TECHNICAL SERVICE BULLETIN

6.7L - Illuminated MIL With DTCs U029D And/Or P2209

18-2365
18 February
2019

Ford 2017-2019 F-Super Duty

Figure 1

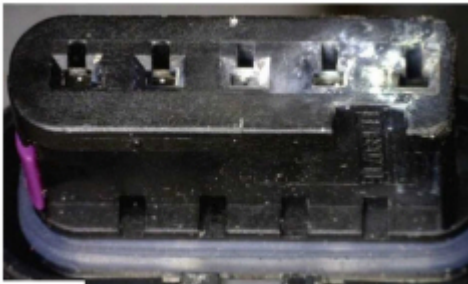
1. Disconnect the nitrogen oxides (NOx) sensor module 11 and inspect for moisture or corrosion on the pins of the sensor or the wiring harness. Are there any signs of moisture or corrosion present? (Figures 1-2)

(1). Yes - replace the NOx sensor module 11. Refer to Workshop Manual (WSM), Section 303-14. Proceed to Step 2.
